ADDENDUM NO. 3

Project: WITCC Culinary Arts Project - Phase 2

Issued: June 27, 2014

EXISTING CARGILL LOBBY - E-100
1 **REVISED ELEVATION**
 SCALE: 1/4" = 1'-0"

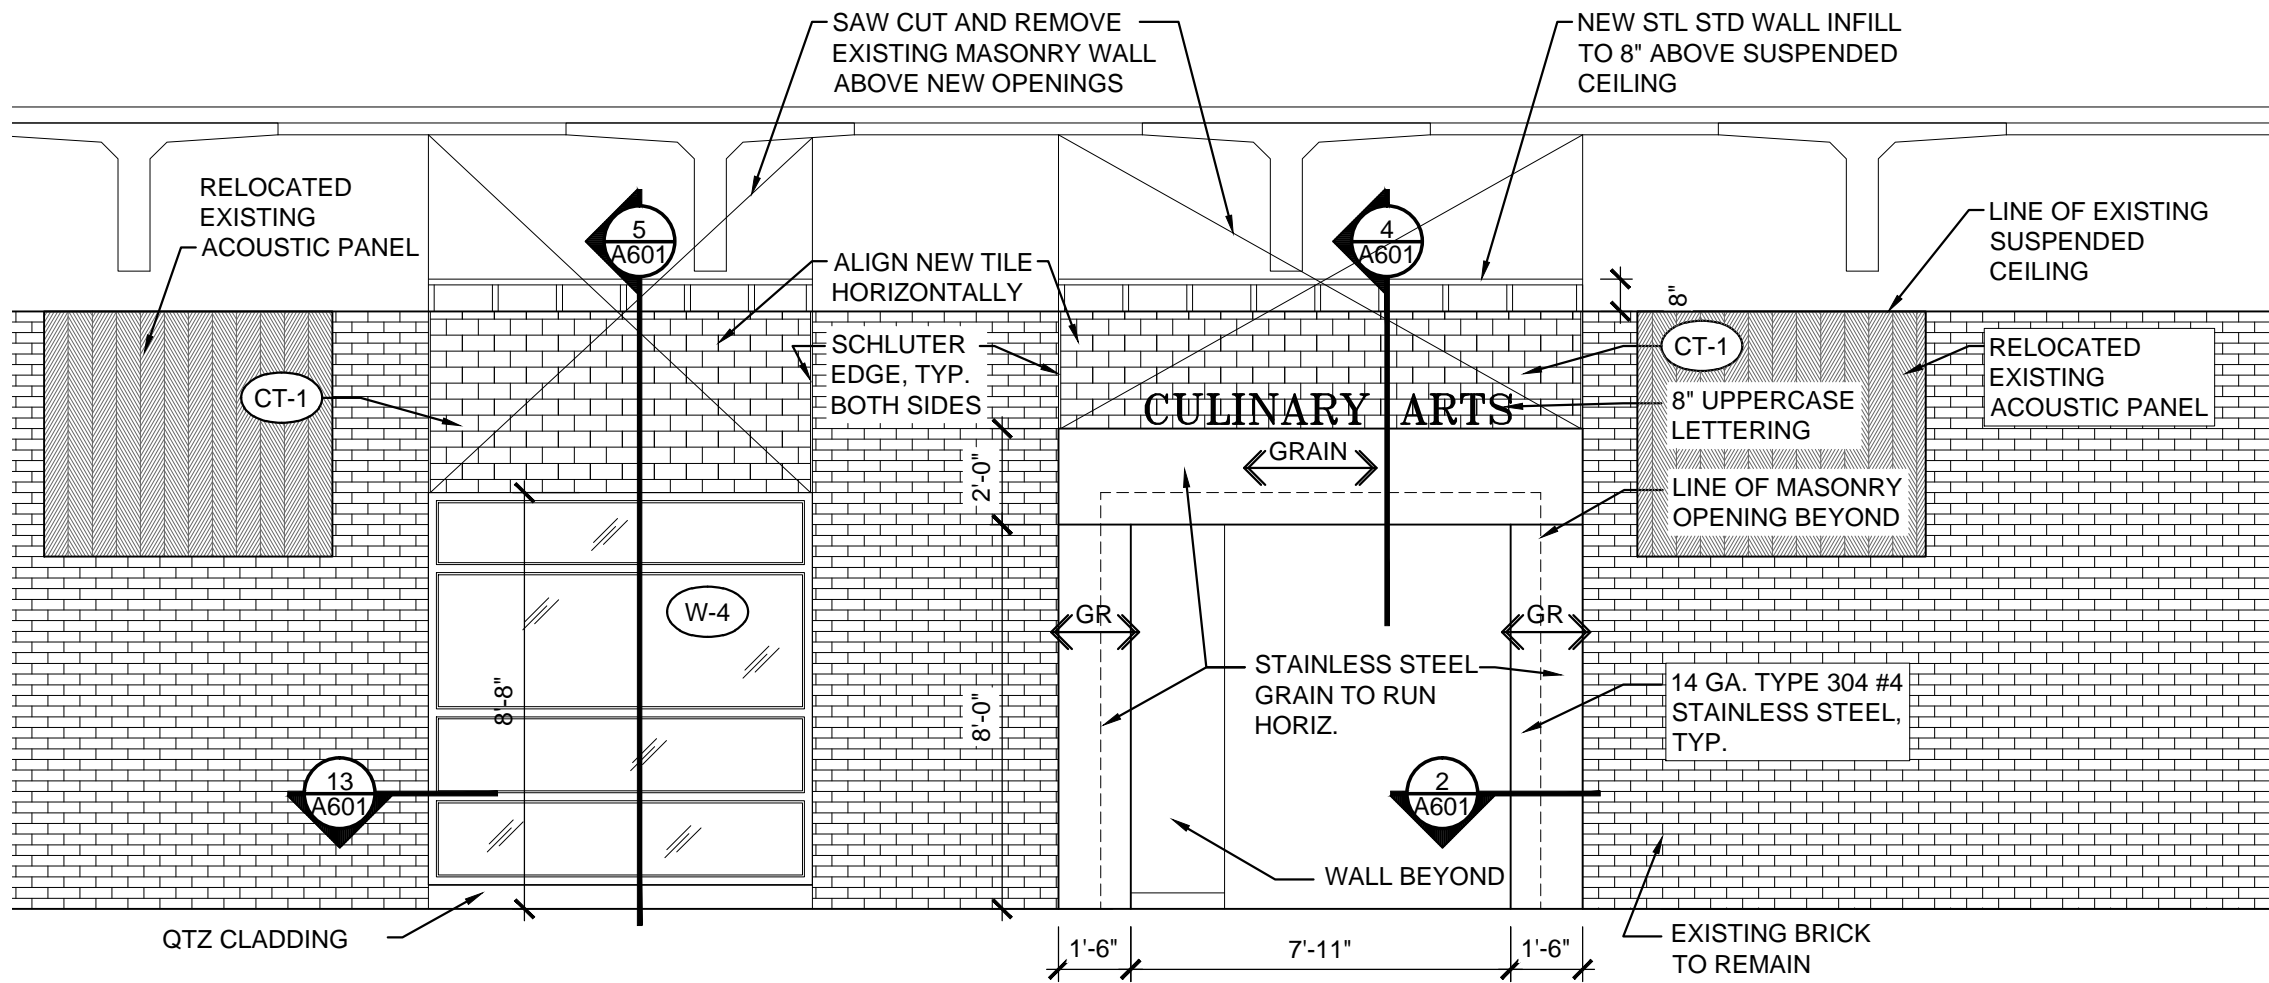
AD3.1. Revision to Elevation 1, Sheet A601 and Sheet S201: See attached Sheet AD3-1 for revision to the masonry work required above the new window and entry openings. The structural steel lintels shown in elevation and in section on sheet S201, and in plan on Sheet S101A will be deleted from the project. In lieu thereof, the existing CMU and brick masonry shall be saw-cut vertically at each opening's jambs, and the existing masonry totally removed from the head of the new openings up to the underside of the concrete roof tee structure.

Carefully remove the existing suspended ceiling on the Atrium (south) side of this wall prior to the masonry demolition, and salvage it for reinstallation after the infill is completed.

The new infill above these two openings shall be constructed of a double-steel stud box header and vertical 20 ga studs, 16" oc, to match the original wall thickness (approx. 12"). The studs shall extend up to 8" above the suspended ceiling height on the Atrium side. Install 5/8" DensShield on both sides of the studs above the window opening and on the Atrium side only above the new Entry; install ceramic tile CT-1 above the new window opening per the attached AD3-1 drawing.
